Amendments to the Drawings

Remarks

FIG. 6H

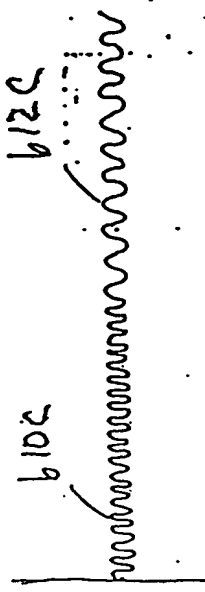
In Figure 6H, the reference number "5410" is being replaced with --610--.

FIG. 55

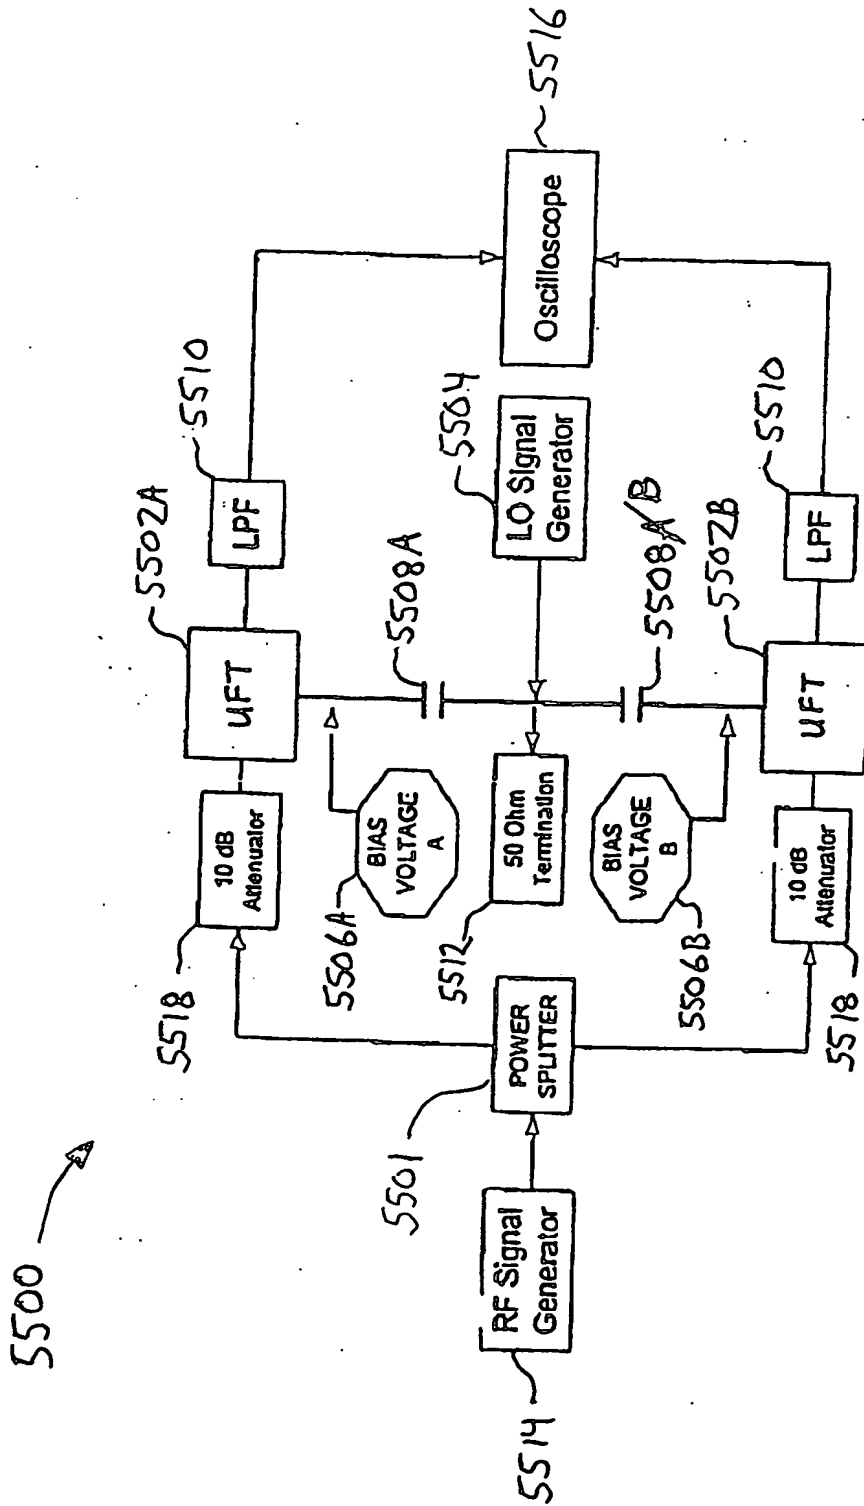
In Figure 55, the 2nd occurrence of "5508A" is being replaced with --5508B--.

FIG. 92A

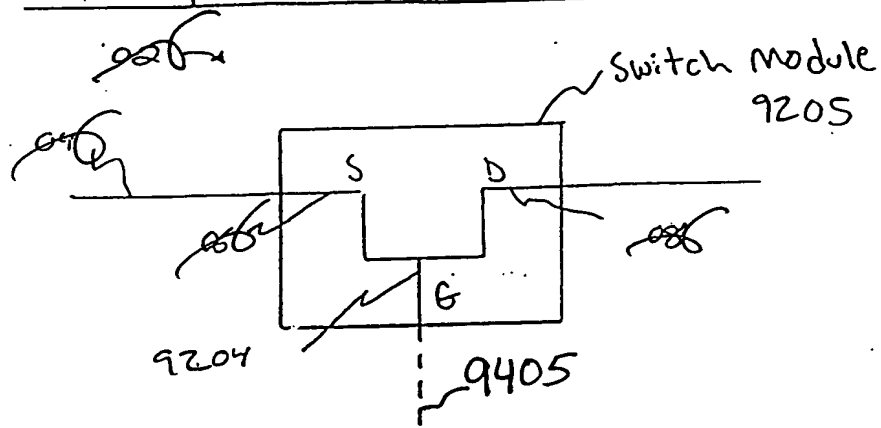
In Figure 92A, any extraneous reference numerals are deleted. Also, the reference label of "9405" is indicated, as described in the specification (for example, see page 43, lines 12-21).

FIG. 92B

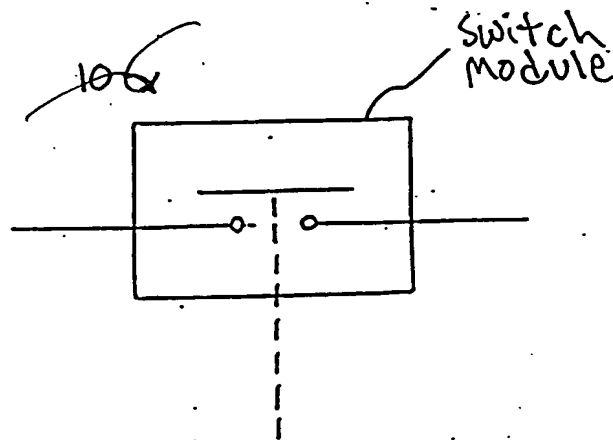
In Figures 92B-92D, any extraneous reference numerals are deleted.
